**From:** Emily Wade <Emily.Wade@midsussex.gov.uk>  
**Sent:** 06 February 2026 16:01:29 UTC+00:00  
**To:** "Catherine Cardin" <Catherine.Cardin@midsussex.gov.uk>  
**Subject:** Cottage Homes, Cuckfield DM/25/3209

Comments on the above planning application.

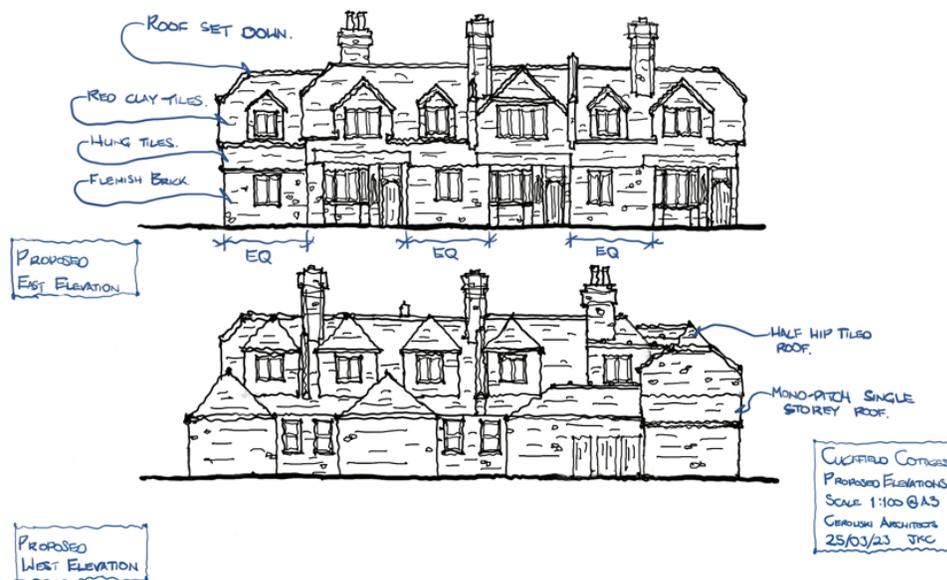
The proposed development site, Cottage Homes, is a short unlisted terrace of almshouses located to the west of the churchyard of Holy Trinity Church, within the Cuckfield Conservation Area. The site is within the setting of Holy Trinity Church, which is Grade I listed, and the churchyard which contains a number of Grade II listed tombs as well as a Grade II listed lychgate and flanking walls to the north of the site.

The terrace, which was constructed between 188-1882 in an Arts and Crafts style, has considerable character, particularly to the eastern elevation, and would be regarded as a non-designated heritage asset (NDHA), based on its historical and architectural interest, and its communal value within the local context. It makes a strong positive contribution to the character and appearance of the Conservation Area, and to the setting of the church and churchyard, which it fronts directly on to. The low boundaries around the east and south of the gardens to the terrace make it particularly prominent in views towards the church and the older part of the church yard from the south and southwest, and in views looking east and southeast from the church and its immediate setting, although the rear of the terrace is also visible in views from a number of positions in Church Platt, including attractive longer views from the west near the junction with South Street which also include the church tower, and close views looking south across the gardens of Masons Cottage/Church Bank House. The terrace was extended to the rear during the late 1950s with a series of flat roofed single floor additions, with flat roofed dormers added to the rear roof slope, which are considered to detract from its appearance. There is a detached single storey outbuilding extending along the rear of the terrace which appears to be original and also contributes positively to the Conservation Area.

**Figure 9H: Large flat roofed single dormer out of scale with the original dwelling**

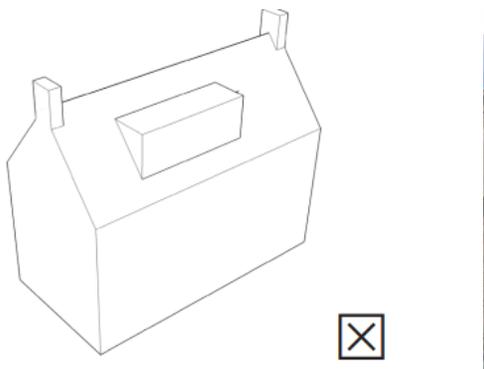
The proposal is also contrary to the requirements of the Council's adopted Design Guide, in particular Design Principle DG49 (General Principles for Extensions) which requires that *'Extensions should... normally be designed to be well-integrated with the existing scale, form and massing allowing the original building to remain the dominant element of the property whether it has one or several additions. Extensions should typically use simple, uncomplicated building forms to complement and coordinate with the scale, form and massing of the original dwelling.'* DG52 (Loft Conversions and Roof Extensions) will also be relevant, and states that: *'Roof accommodation is normally reliant on dormer windows and rooflights to provide light and ventilation. However, if they are out of scale or out of character with the roofscape and proportions of a dwelling they can have an adverse impact on the character of both the dwelling and the streetscape'*. Figure 9H also applies:

Also relevant are sections 6.3.5. to 6.3.7, which refer further to dormer windows, including the following: *'Dormer windows should be visually subordinate to the roof slope, enabling a large proportion of the main roof to remain visible. Excessively wide dormers are likely to look unsatisfactory as they will often be out of proportion with the existing roof.'*
